**MONTGOMERY COUNTY HISTORIC PRESERVATION COMMISSION**  
**STAFF REPORT**

<b>Address:</b>	10155 Laureate Way, Bethesda	<b>Meeting Date:</b>	11/13/2019
<b>Resource:</b>	Master Plan Site 30/15 Wild Acres	<b>Report Date:</b>	11/6/2019
<b>Applicant:</b>	Robert Gilroy & Kathy Said	<b>Public Notice:</b>	10/30/2019
<b>Case Number:</b>	30/15-19A	<b>Tax Credit:</b>	n/a
<b>Review:</b>	HAWP	<b>Staff:</b>	Dan Bruechert
<b>Proposal:</b>	Garage Construction, Deck Construction, Hardscape Alteration

# Site Plan

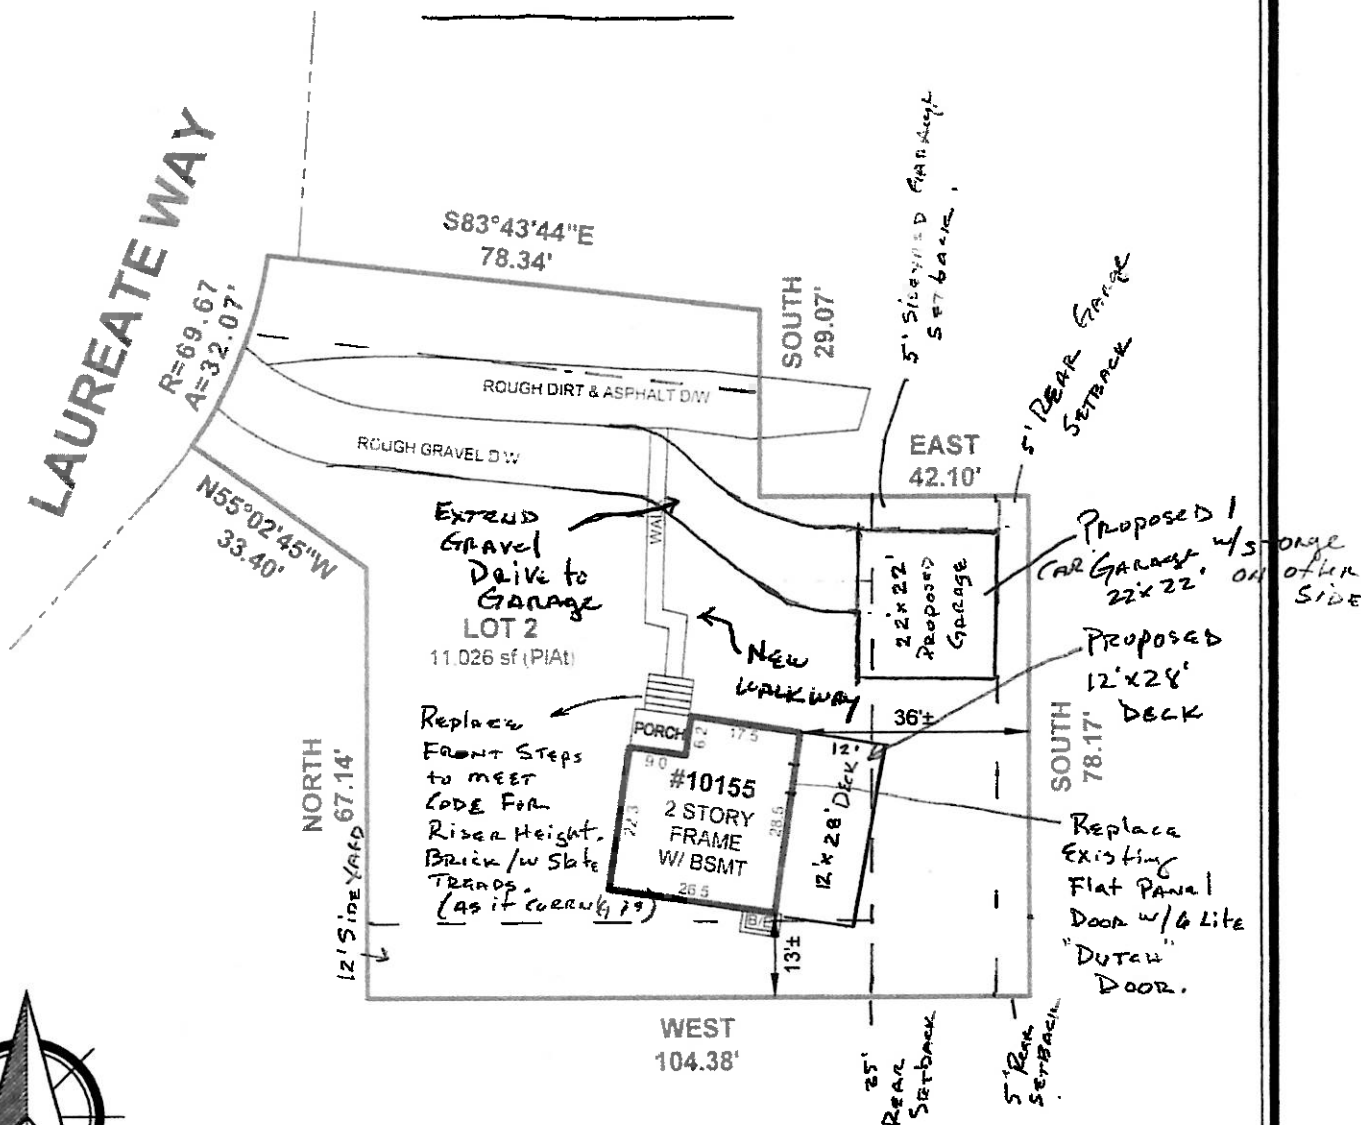
The proposed new driveway will be to the right (south) of the existing drive, in part, because the existing drive runs off the property and into a conservation area. The new drive will be crushed gravel and will run from the street to the garage.

The existing walkway will be removed and replaced with a new concrete walk. The new walkway will be installed in the same location as the existing, but will be shorter due to the location of the proposed driveway.

Staff finds both the proposed driveway and walkway are compatible with the historic character of the lot and the surrounding landscape. The gravel drive will provide a natural color and texture that will blend in with the surrounding landscape. The walkway is effectively a replacement in kind, but because the dimensions have been altered, Staff finds that this should be subject to HPC approval. However, Staff finds that this replacement is in keeping with the features and character of the house and recommends approval of both of these features under 24A-8(b)(2) and Standard 2.

# PROPOSED GARAGE 10155 LAUREATE WAY

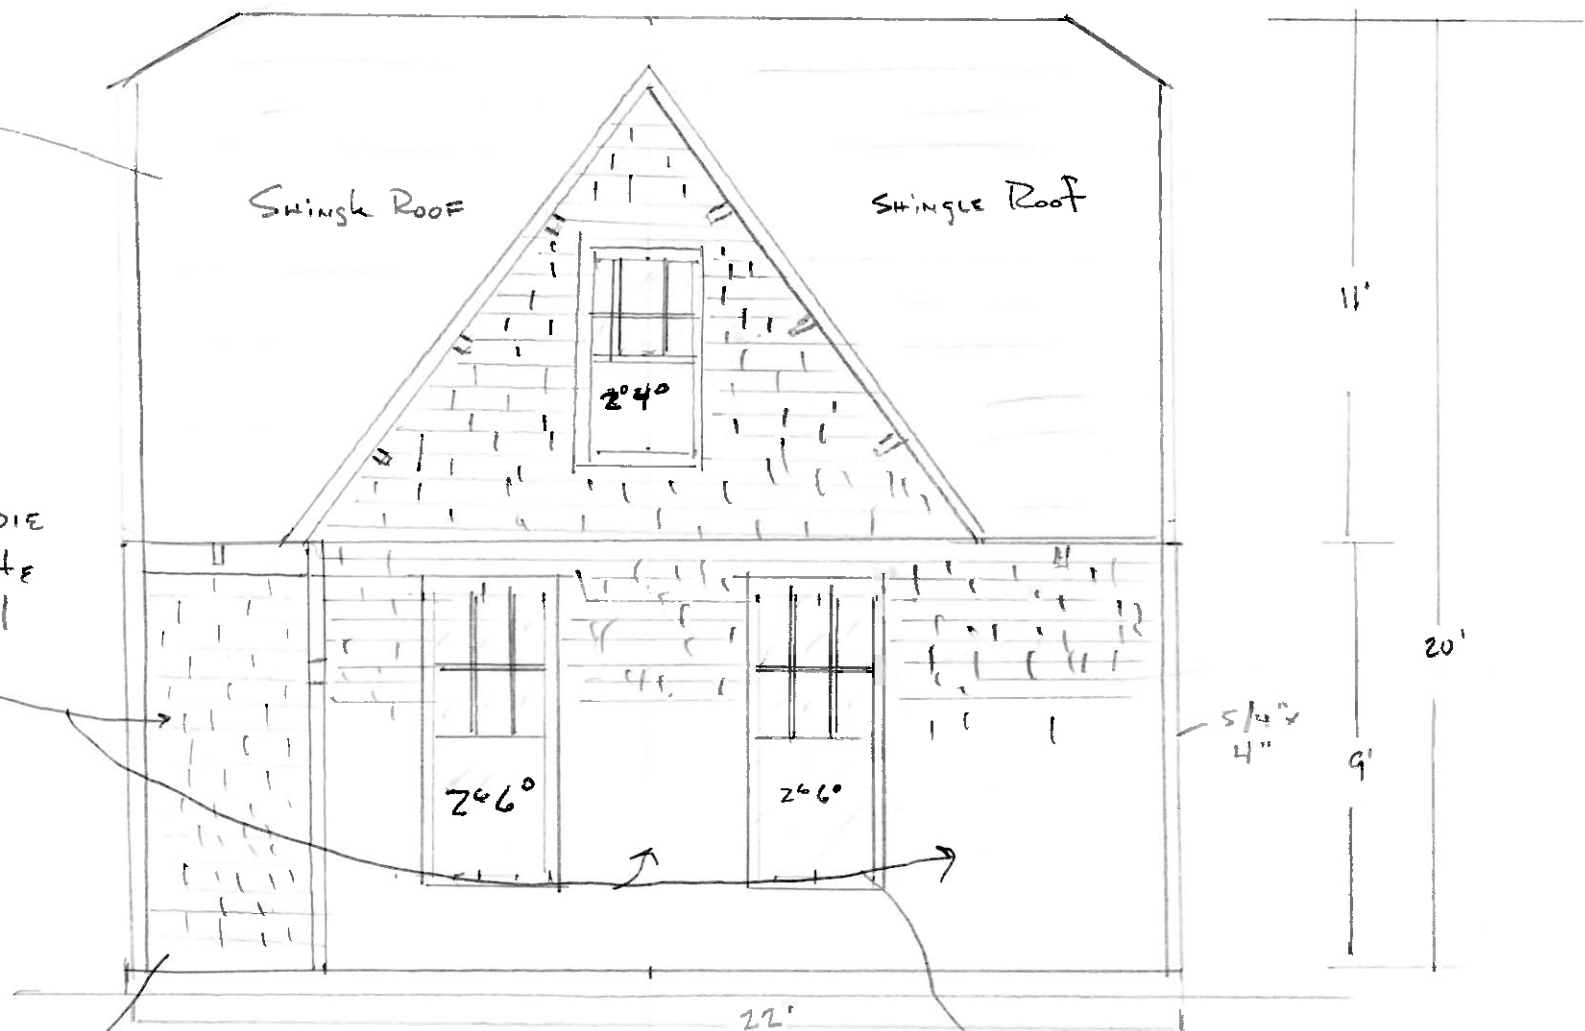
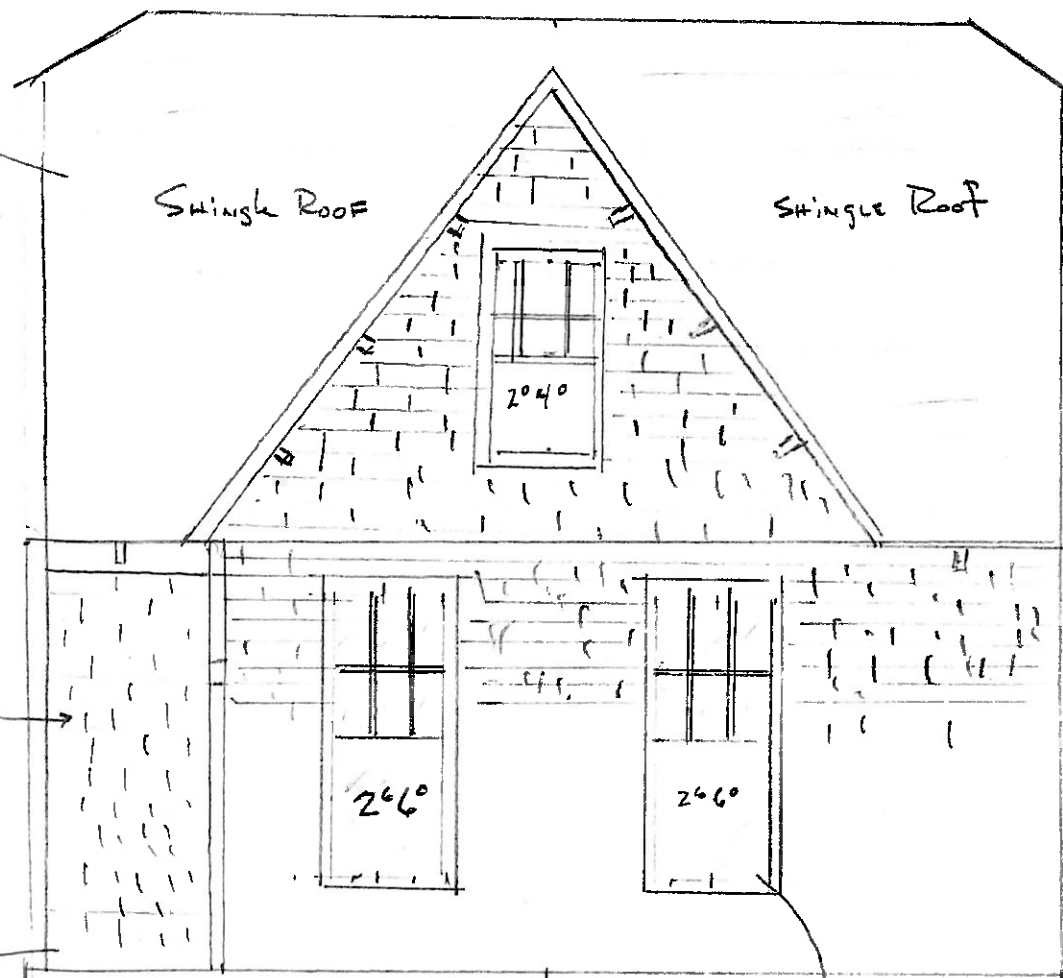
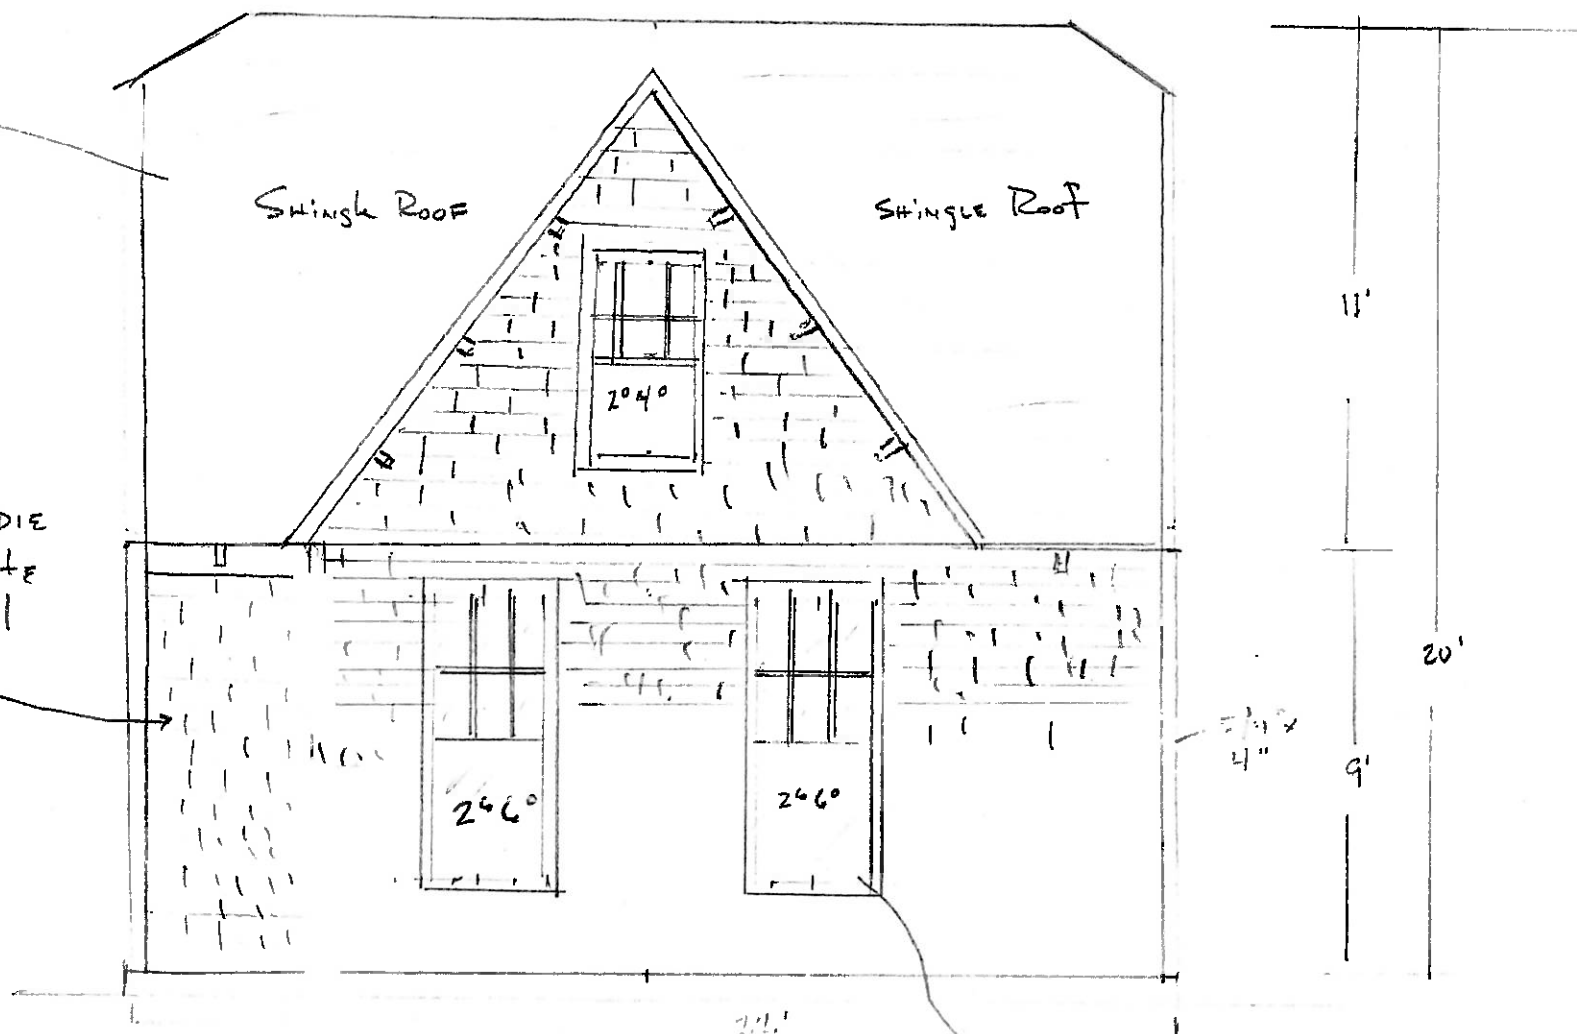
The applicant proposes constructing a 22’ × 22’ (twenty-two foot by twenty-two foot) detached, single-bay garage, built on a poured concrete foundation. The garage will have cross gable roof covered in asphalt shingles and be clad in Hardie fiber-cement shingle siding. The single garage door will be constructed out of wood with a row of windows along the top of the door. The door to the right of the car entrance will be a wood, half-lite door with six lites. The garage will have six-over-one, true divided lite, aluminum clad wood windows on each elevation. Overall, Staff finds that the proposed garage is compatible in design, size, form, and details with the historic caretaker’s house. The shingles, while a different material and a flatter profile than wood, are inspired by the wood shingle siding on the historic house. Additionally, the proposed windows match the configuration and dimensions of the historic wood windows throughout the house.

Staff finds that the garage design and materials are compatible with the historic house, while sufficiently differentiated to be recognized as new construction. This is in keeping with the guidance provided by Standards 9 and 10 and 24A-8(b)(2). Staff recommends approval of the proposed garage.

# REAR Deck Elevation

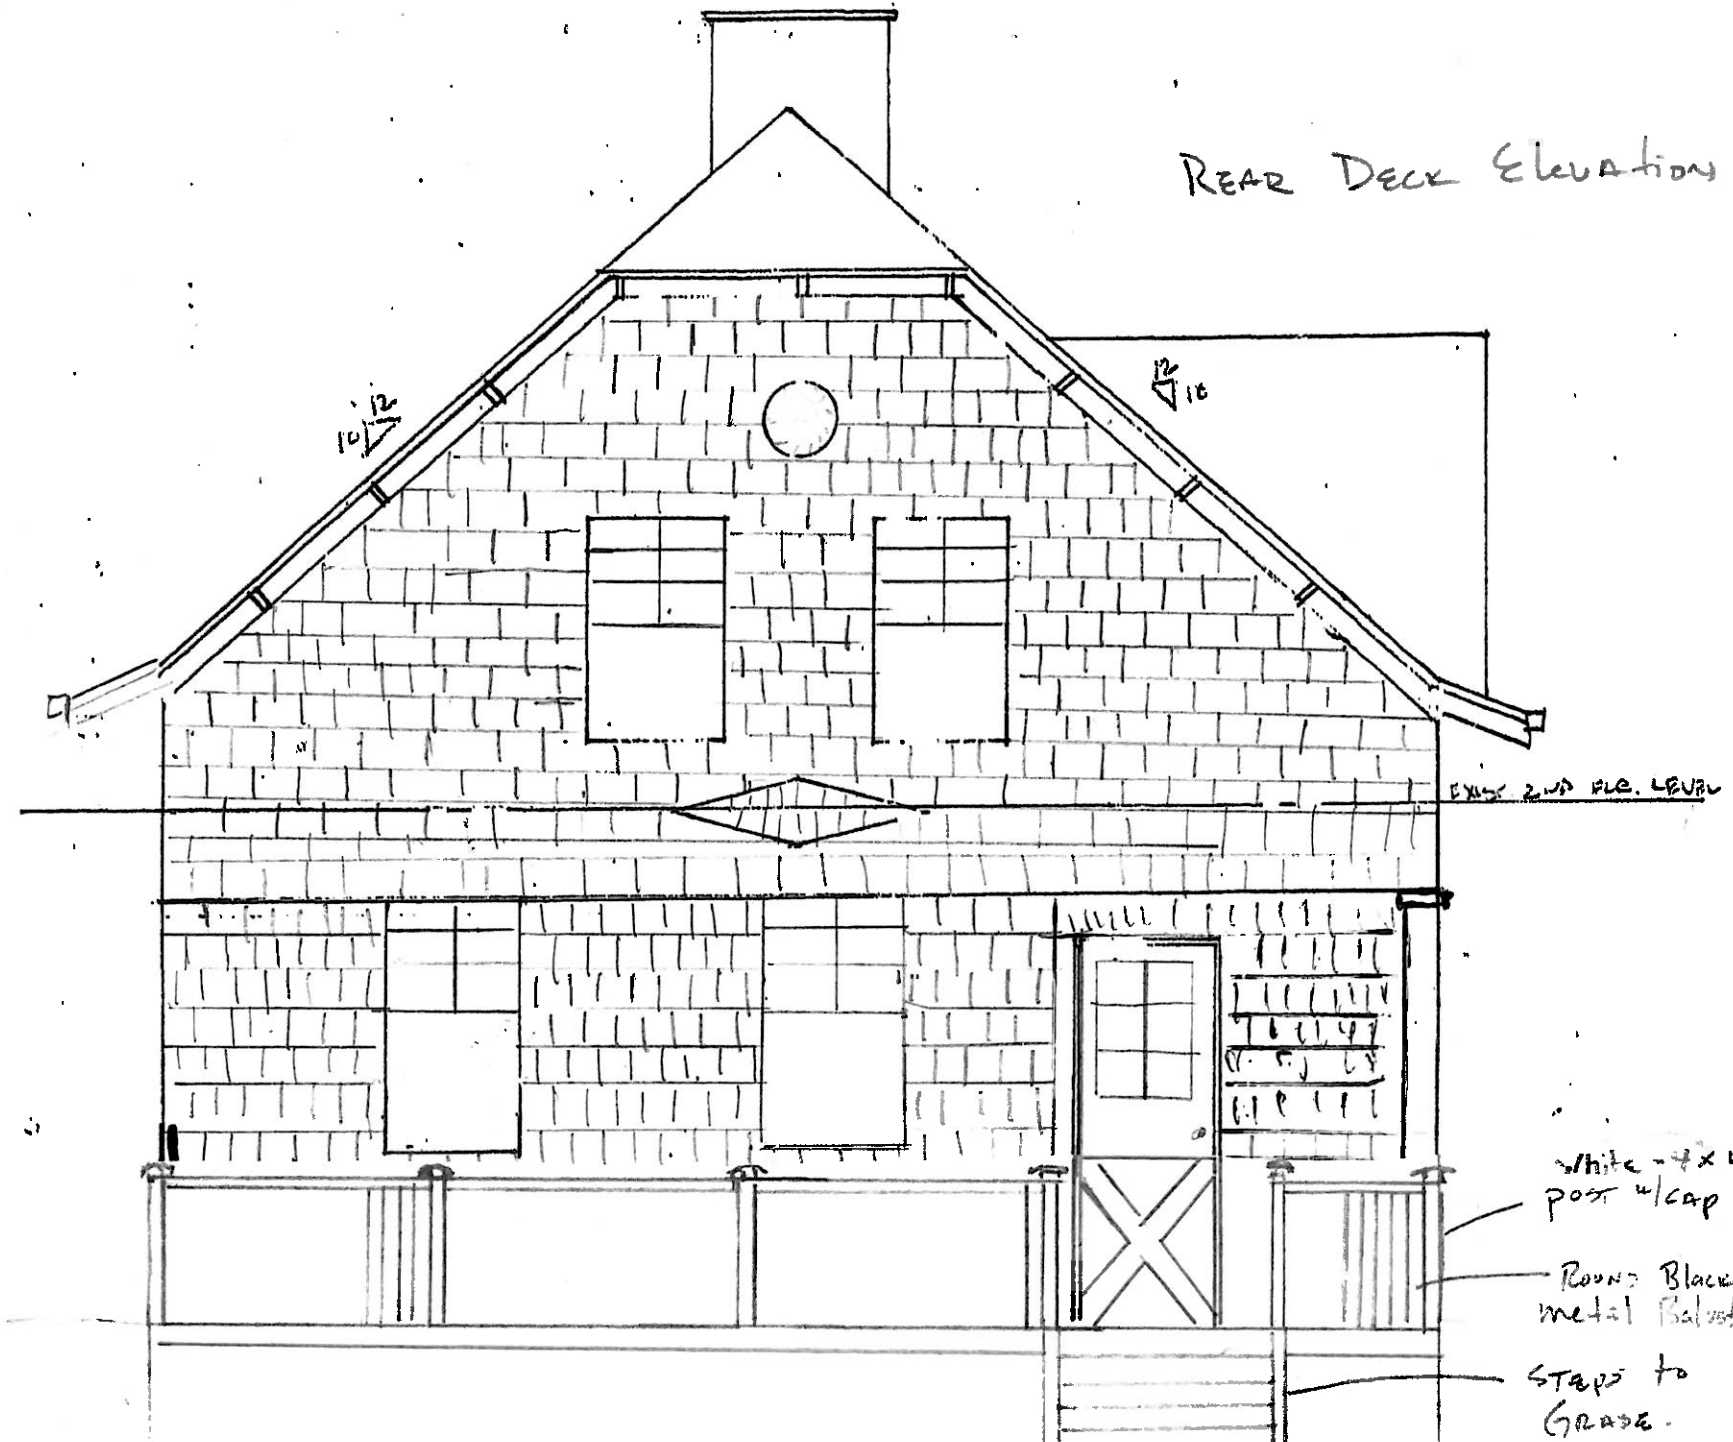
At the rear, the applicant proposes to construct a 12' × 28' (twelve foot by twenty-eight foot) wood deck with a vinyl and metal railing. The proposed deck will run the full width of the rear elevation and will be approximately 36" (thirty-six inches) above grade – at the height of the foundation. Due to the height of the proposed rear deck, the deck requires a railing to meet code. The applicant proposes to use a vinyl and metal railing surrounding the deck.

Staff finds the size, placement, and materials of the deck will not detract from the historic features on the house. However, Staff finds the proposed vinyl and metal railing is not compatible with the materials and design of the house and should not be approved. The proposed railing will introduce two new materials to the house in a finish that is too shiny to be compatible with the wood house and its brick foundation. Staff recommends the HPC add a condition for the approval of the porch that the railing needs to be constructed out of wood with pickets inset between the top and bottom rails, and that final approval authority of a railing meeting these criteria is delegated to Staff for review and approval.

1. The proposed vinyl and metal railing for the proposed rear deck is not compatible with the materials or design of the house and is not approved. The railing for the deck needs to be wood with the pickets inset between the top and bottom rails. Final approval authority of the rear deck railing meeting these criteria is delegated to Staff.
2. Any approval of this HAWP not extend to the removal and replacement of the front stairs.

Rear of House. This is where we would like  
to build the 12' x 28' deck

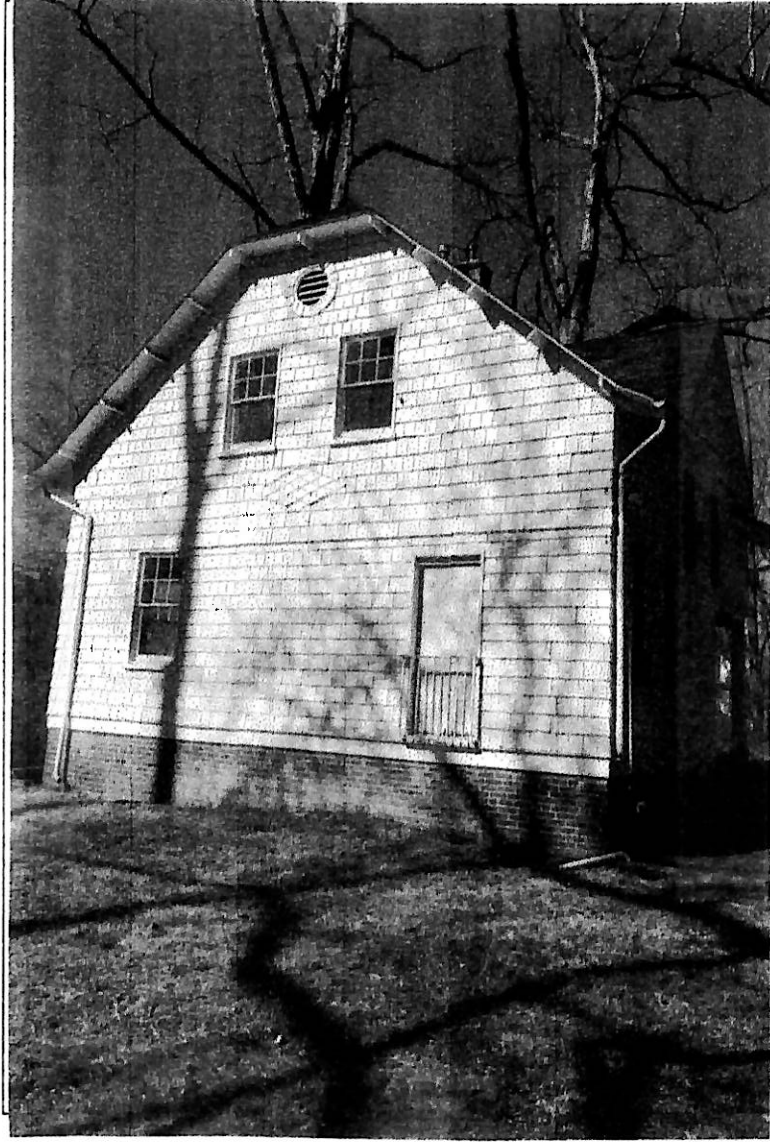
At the rear of the house the applicant proposes to construct a new wood deck. A 1999 file photo shows what appears to be an enclosed rear porch. Staff has been unable to determine the date this feature was removed, however because Wild Acres was not listed on the Master Plan for Historic Preservation until 2008. It is possible the porch removal occurred prior to its listing. Staff finds there is a precedent for a rear porch and finds that the proposed porch will have only a limited view from the public right-of-way.

To provide access to the rear deck, the applicant proposes installing a new wood, half-lite door to replace the existing plywood covering. The proposed half-lite door will be installed in the existing, historic opening and will match the design and materials for the door proposed in the garage. Staff finds that the proposed half-lite wood door, in the rear of the house, is appropriate and will have minimal impact on the historic character of the house and surrounding site. Staff recommends approval of the rear door under 24A-8(b)(1) and (2) and Standard 2.
